HUGHES ENVIRONMENTAL CONSULTING

April 16, 2021

I am writing on behalf of the Port Place Development to request approval for a number of minor revisions to the overall plans that were approved under DEP file number 051-0973. Attached you will find plans and supporting information for these changes, which include:

PORT PLACE
by Evergreen Commons, LLC
Newburyport, MA

OVERALL LANDSCAPE PLAN
Scale: 1"=70'-0"

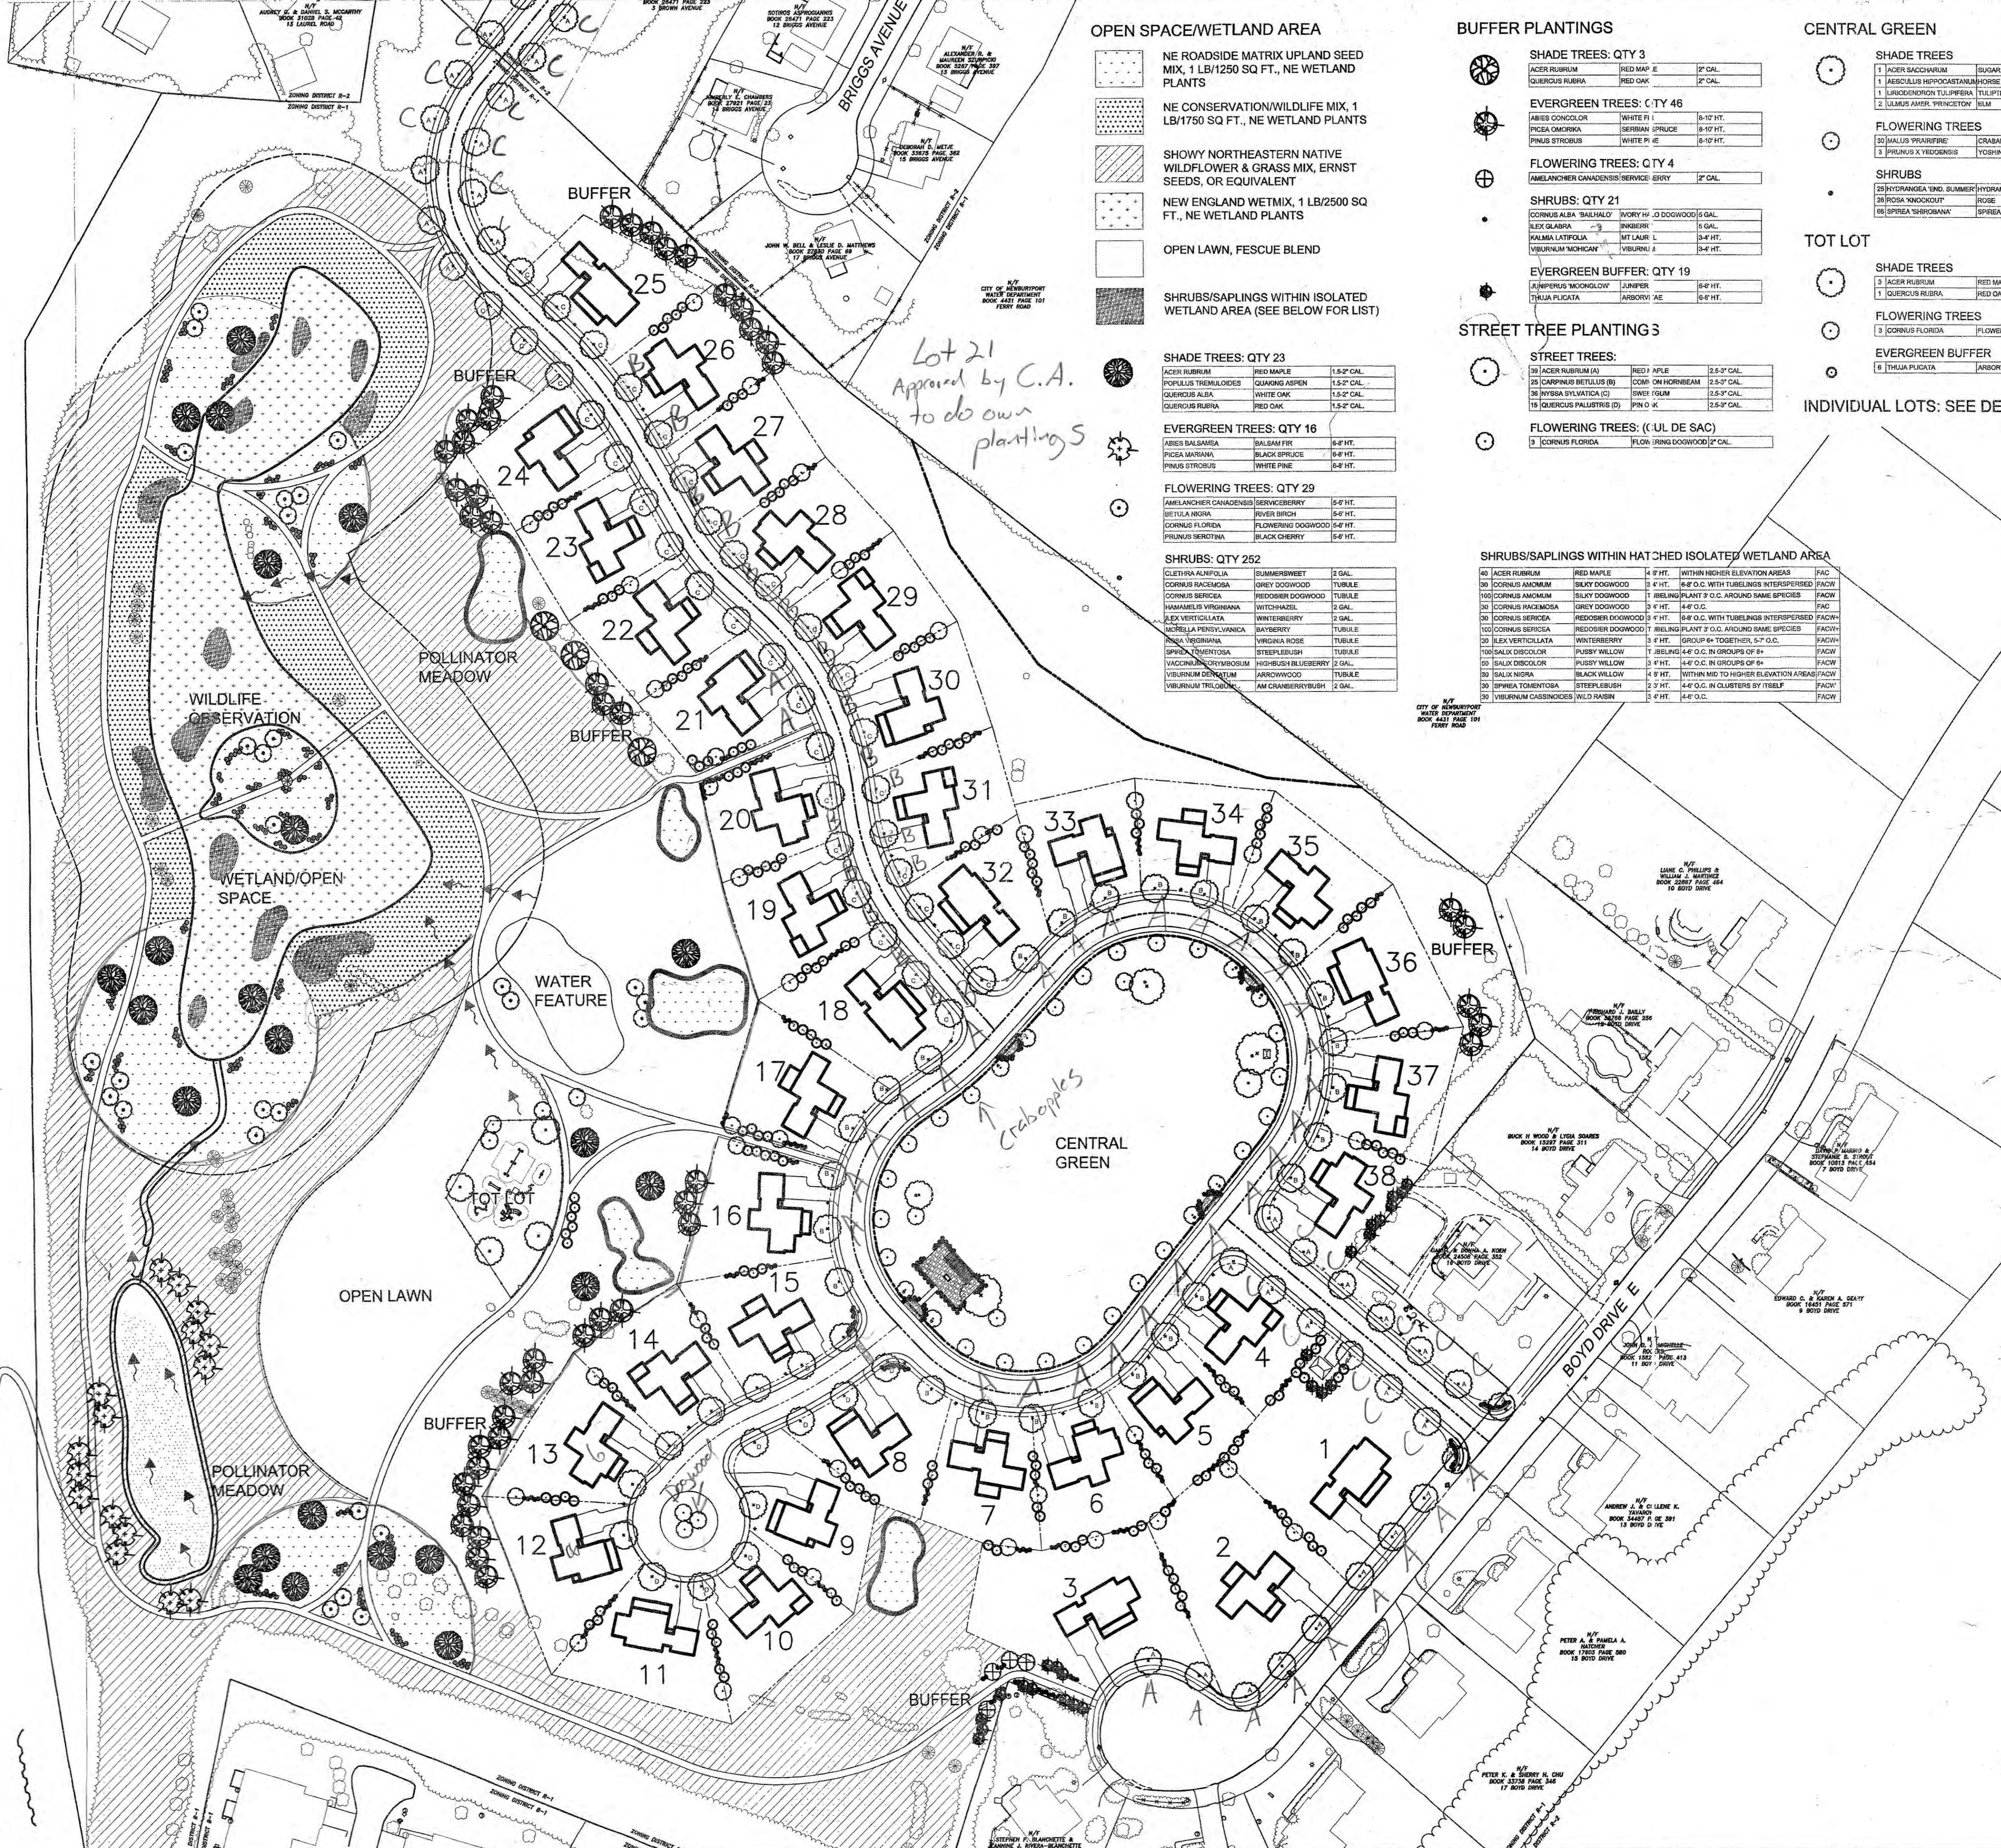
1. Removal of the singular bridge crossing and the pathway that connects to that bridge. This was discussed with City Staff during a field visit earlier in the project. The bridge is an unnecessary impact to the IVW.

2. Adjustments to the planting in the open space, including:
 - a. a small shift of plants from the singular bridge approach to the double bridge approach;

- b. an adjustment to add area to the pollinator meadow on the east side of the area of the singular bridge (see updated sheet L-0);
 - c. a new category for the meadow area south and west of the IVW "Transitional Meadow" which includes shrub and tree plantings that better fit within these areas that abut wooded areas. We will be planting approximately 400 native shrubs and saplings in this new area to transition from the open meadow areas to the wooded areas and allow for better habitat in these shadier areas near the existing woodland;.

- d. A slight change in the path location to reduce slope for accessibility reasons in the northeastern entry to the path network;
 - e. Infrastructure changes associated with stormwater as noted below; and

- f. A perimeter drain pipe installed around the tot lot to allow it to dry quickly after rain. This small drain outlets on the slope of the pond.
3. Adjustments to which species called for in the street trees were planted in which locations. The same list of species was used, but which trees went where is different. A markup showing what was installed from the species list where is attached.

**PORT PLACE
LANDSCAPE PLAN**

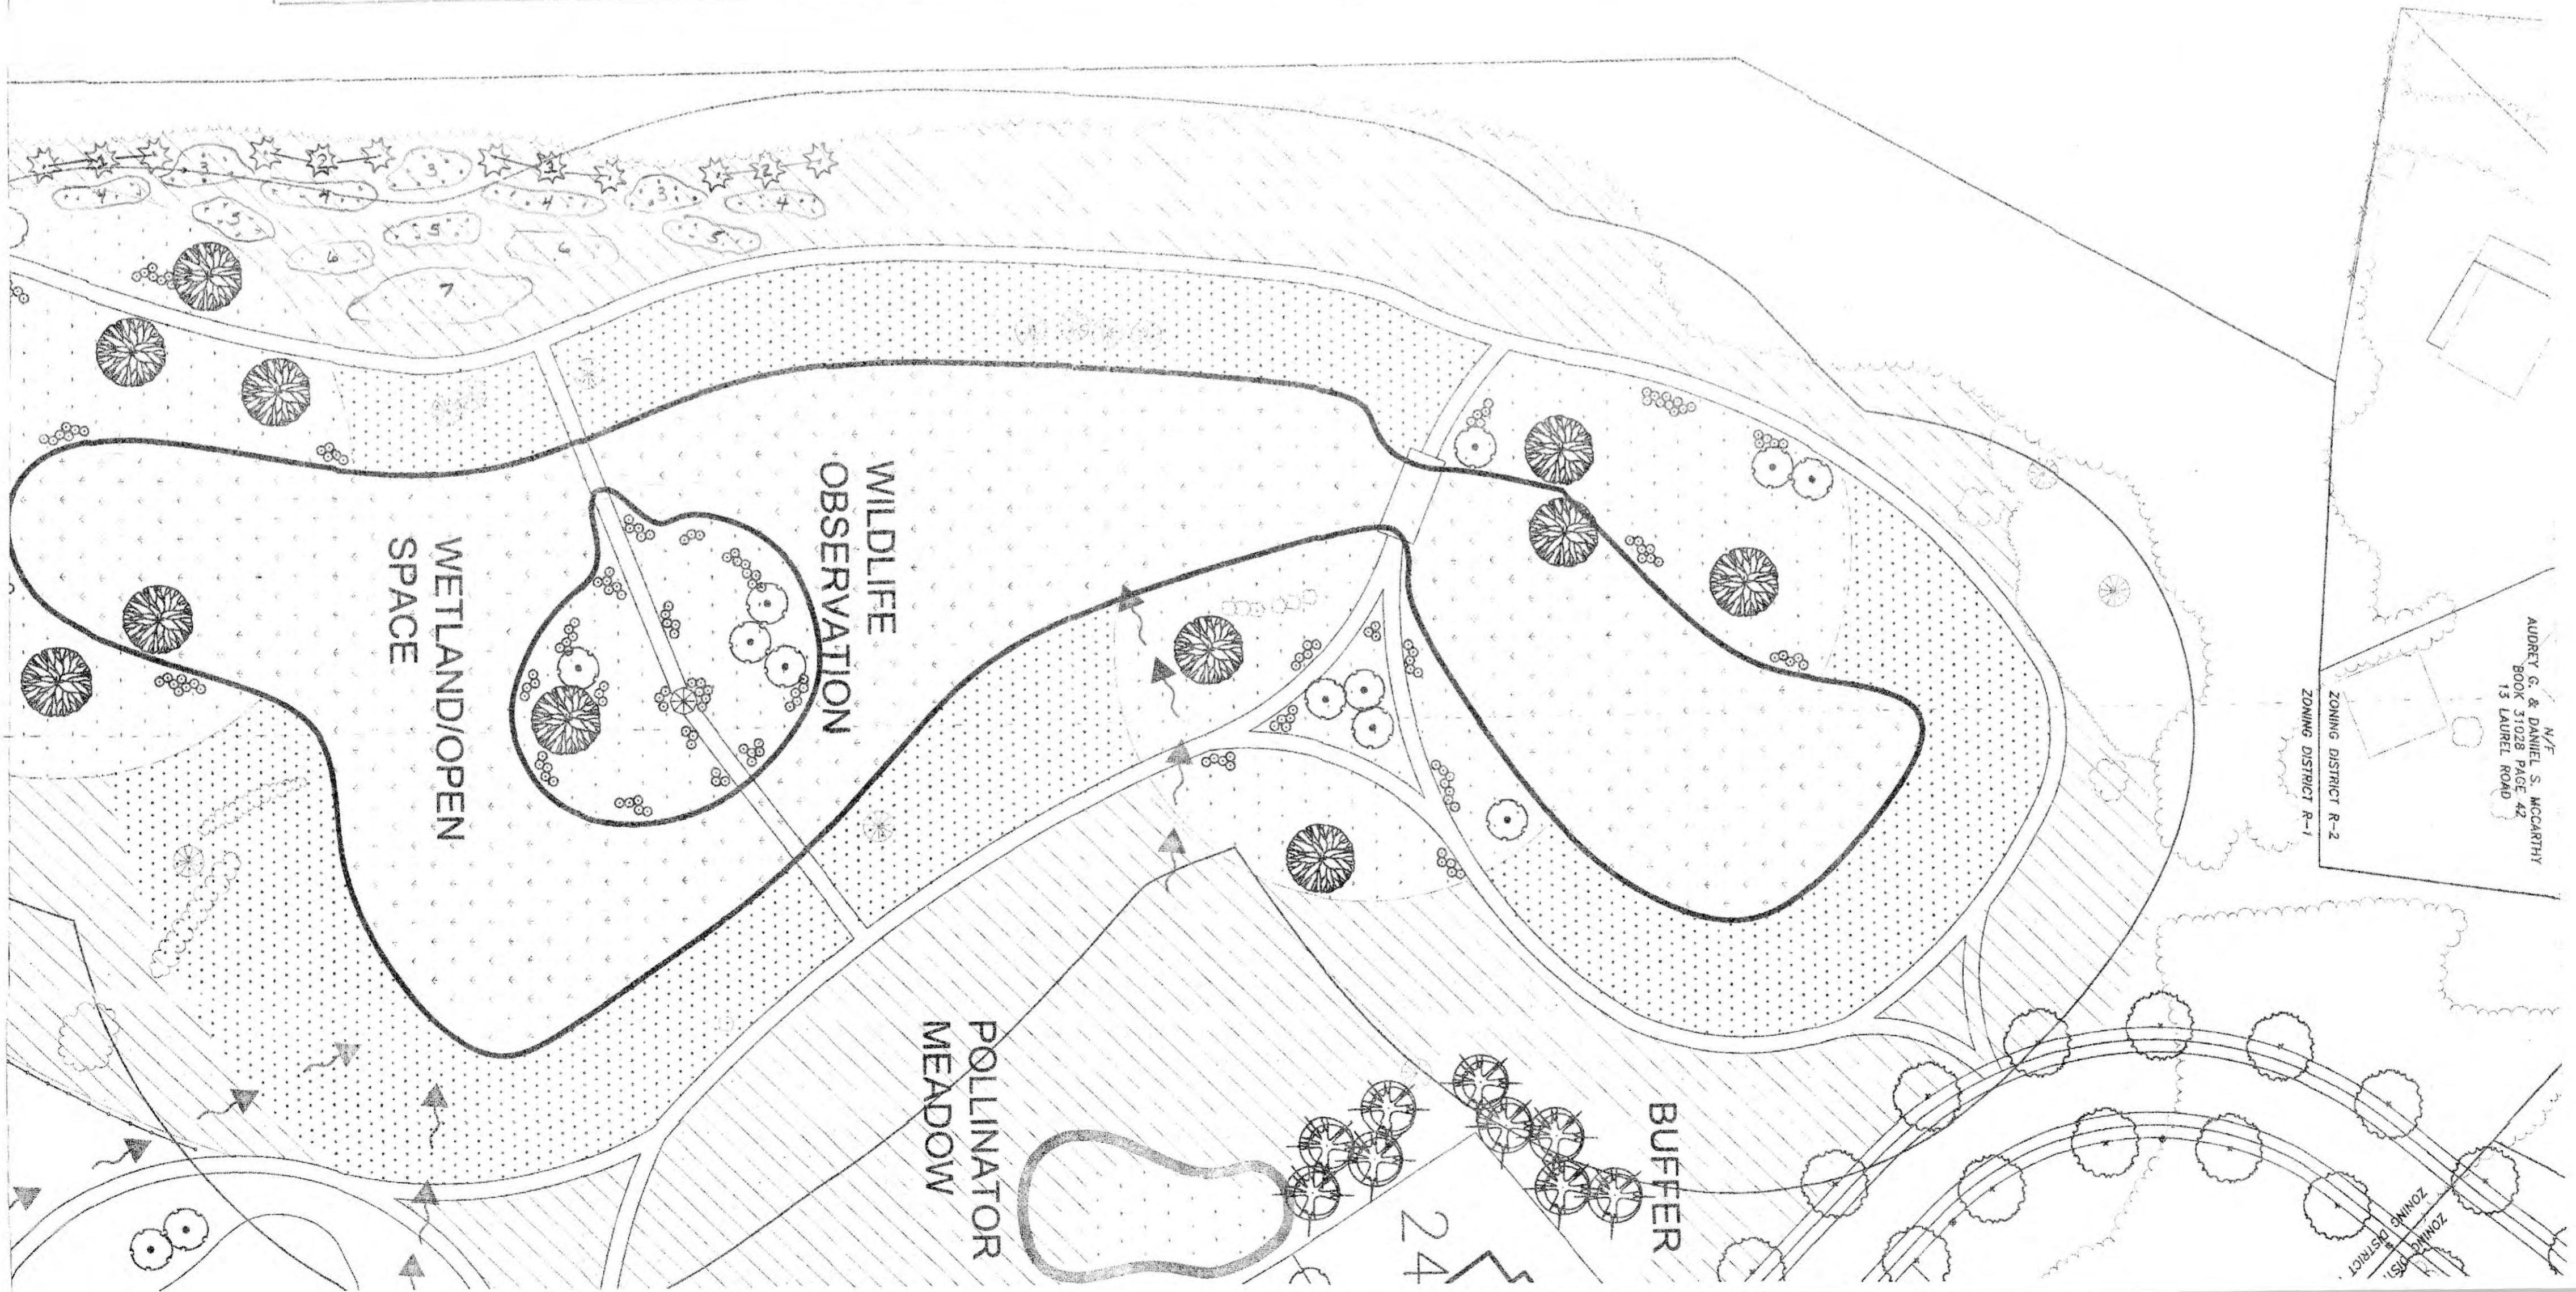
Attached you will find two updated plan sheets, a hand mark up of sheet L-1 showing the street tree changes, and two hand mark ups of portions of the landscape plans for the Transitional Meadow Area. Additionally, we have updated sheet L-0. The copy of L-0 attached is being colored in. We will provide a colored in copy of this sheet prior to the meeting. Additionally, we will be notating the maintenance chart to state that mowing in all areas must go around shrubs and trees for clarity. The Transitional Meadow will be maintained at the same time as the Pollinator meadow.
